August 15, 2023 Business Meeting Memo

STAFF PLANNER: Sam Walker – Planner II

SPR-22-0075: Van Matre Residence

Request: Site Plan Review to deconstruct the existing residence and accessory structures before constructing a new 3,417 sq. ft. residence and 395 sq. ft. carport on a 1-acre parcel where the presumptive size maximum is 3,429 sq. ft.

Figure 3: Existing site plan submitted with the original application materials indicating a 42' 5" setback for the existing residence, as well as similar setbacks on nearby parcels to the south.

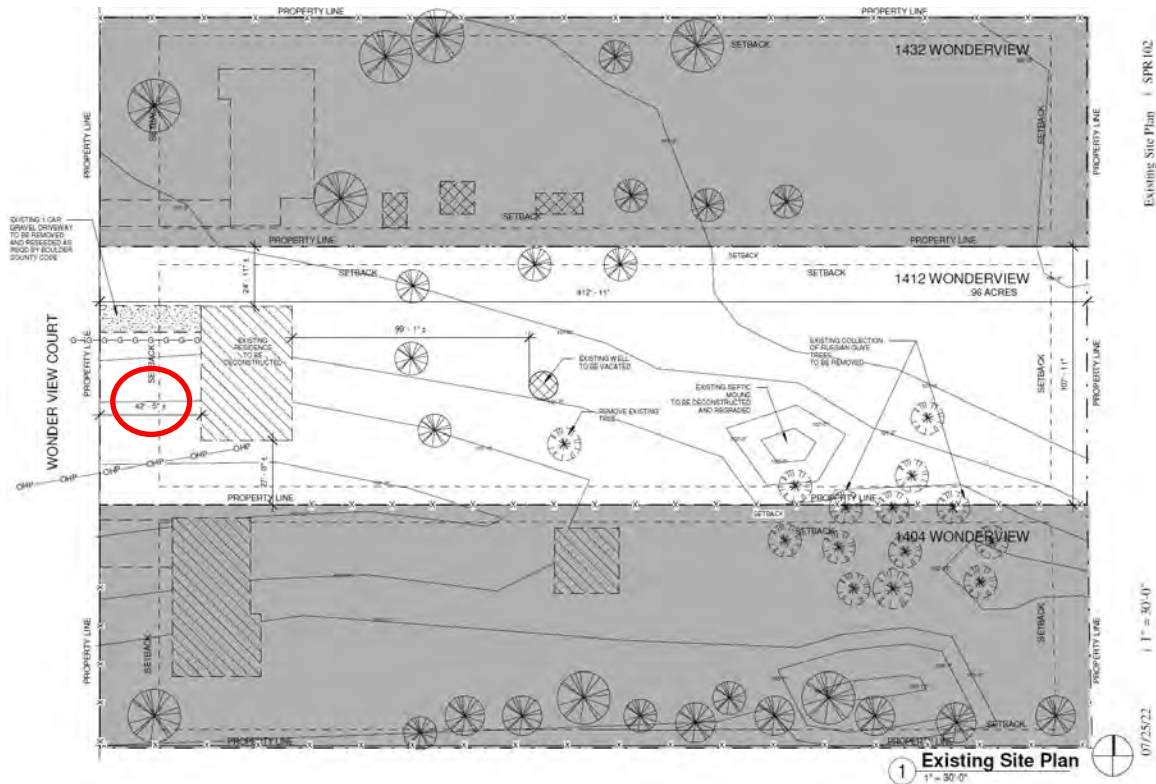
The submitted application materials include an existing site plan exhibit indicating that the existing (to be deconstructed) residence is located at an approximate 42' 5" setback from the western (front) parcel boundary (See Figure 3, below). The original proposal for redevelopment of the property indicated that the new residence would be located at a much larger setback of 130' 2" from the western parcel boundary.

Staff raised concerns that such a substantial setback would be significantly out of character with the existing pattern of development in the defined neighborhood, where nearly all of the residences are located very close to the front property line and have expansive rear yards.

Staff still have significant concerns regarding the substantial change in the setback between the residence and the western parcel boundary because the predominant pattern of development within the defined neighborhood places residences much closer to the front property line than has been proposed by the applicant. The proposed location would conflict with the visual character of the defined neighborhood and is a cause for concern related to impacts on the Sombrero Marsh as described in the BCPOS referral response.

the west side of the residence. The revised submittal also included an overall conceptual site plan for the subject parcel and two adjacent parcels to the north and south (which are also under active Site Plan Review) to illustrate that the increased setback was a function of the required setbacks between the septic systems and water wells on all three parcels. Therefore, the proposed location for the residence is approved as proposed in the revise application materials described in the chart above.

1 Site & Drainage Plan
 1" = 30'-0"

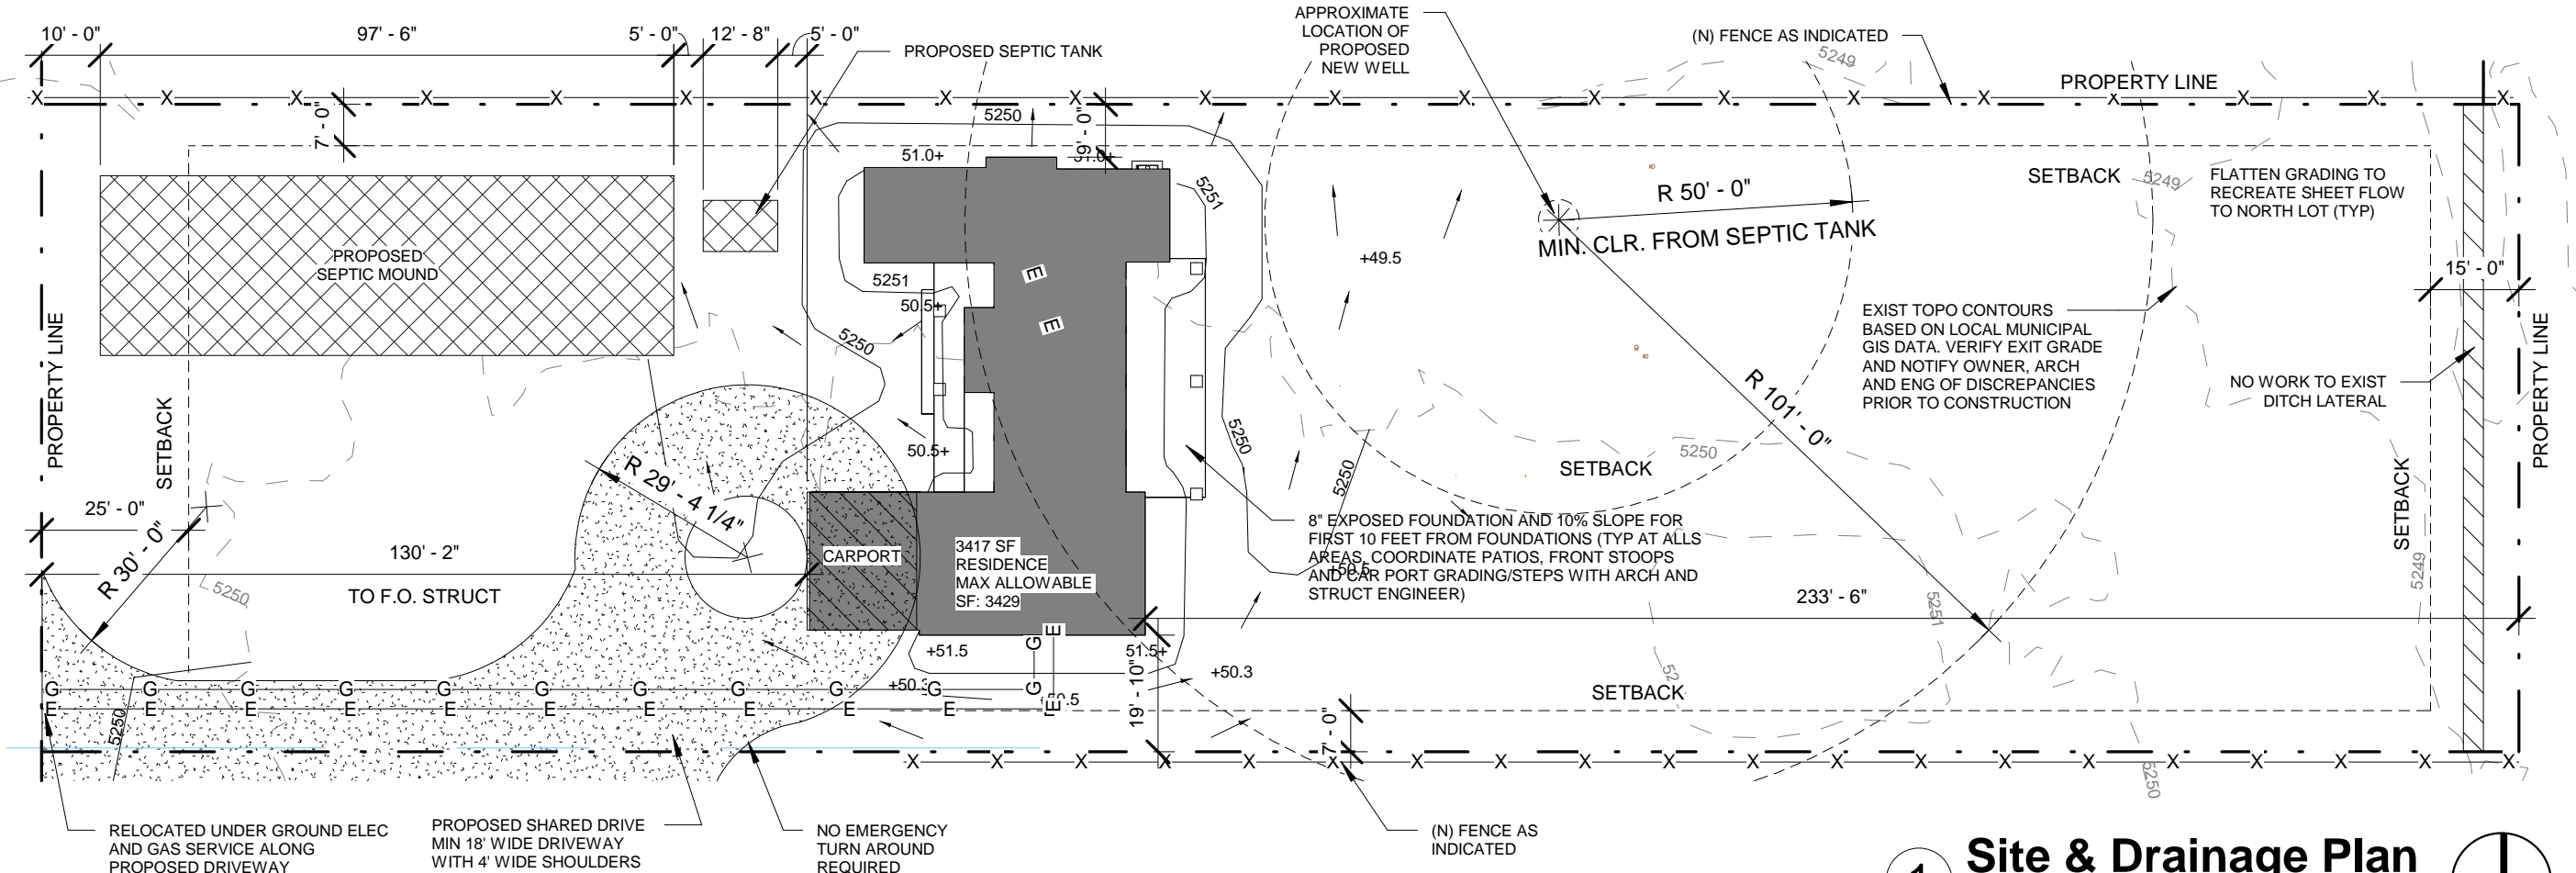
At building permit, provide updated plans demonstrating that historic drainage is maintained as well as compliance with SDCM Section 1202 Low Impact Development such that at least 20 percent of the total impervious area of all new development and redevelopment sites drain to a pervious area equal to at least 10 percent of the total impervious surface area of the development site, prior to discharging from the site. The updated plans must also show that no grading will take place within two feet of any property line.

1 Grading Plan

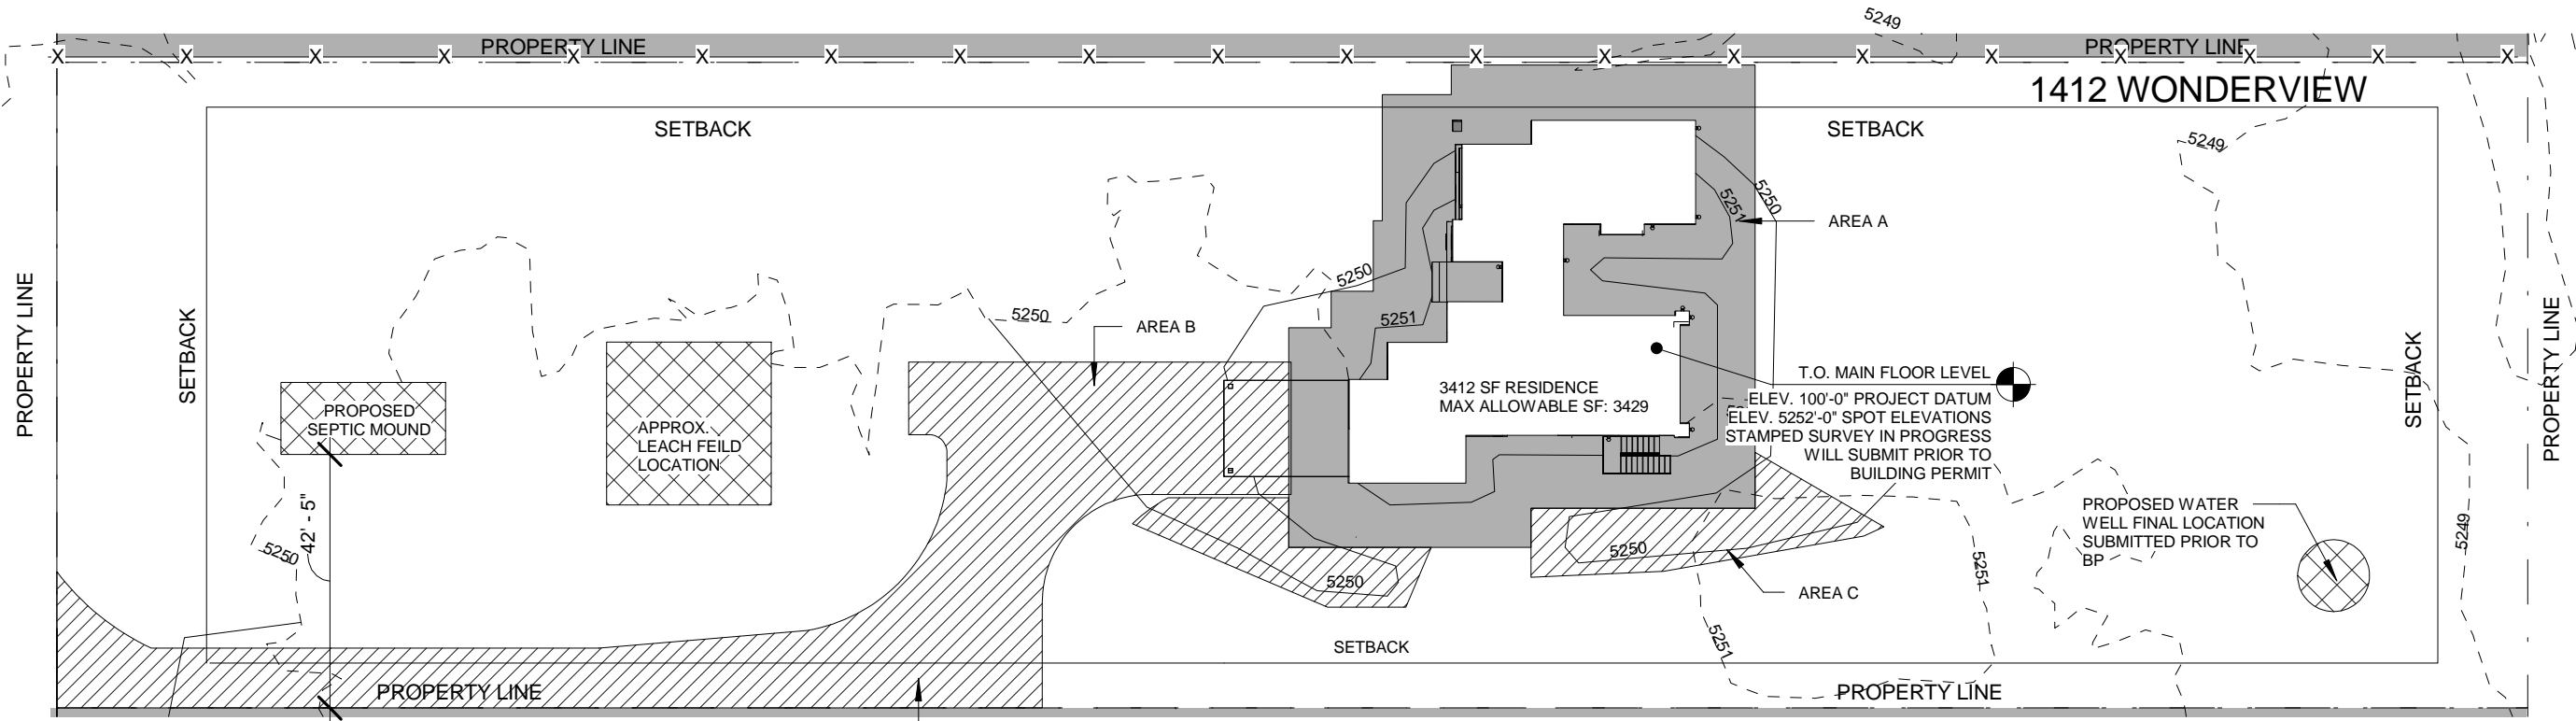
4. The revised grading plan dated 2/14/2023 (attached) indicates 97.72 cubic yards of fill will be used along the driveway. The improved driveway must comply with the [Boulder County Multimodal Transportation Standards](#) (“the Standards”) for residential development, including without limitation:
 - a. Table 5.5.1 – Parcel Access Design Standards (1-Plains Access)
 - b. Standard Drawings 11 -12 – Private Access

5. Applicants have proposed a shared access drive with the adjacent property at 1404 Wonderview Court. Reducing the number of accesses from two to one may represent a safety improvement. This design, however, does not comply with side setback requirements per standard drawing 12 found in the Standards, Therefore, a Design Exception Request is required.

Approximate location of proposed house looking south to 1432 Wonderview

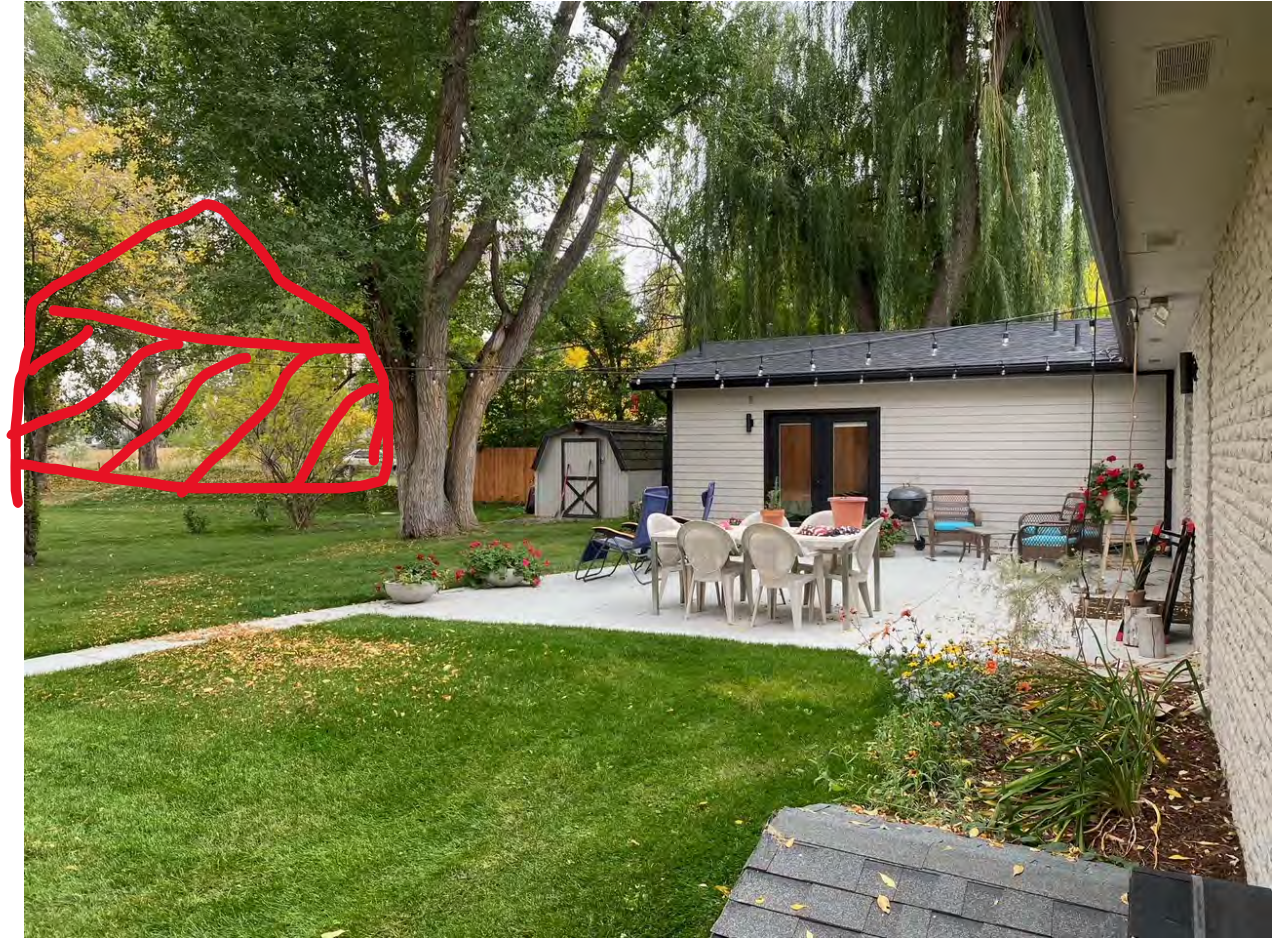
To be consistent with Boulder County Standards (2, 4, 10 & 14) and the goals of the Boulder Valley Comp Plan, the house location should be denied. The replacement structure should be placed on or near the existing house.
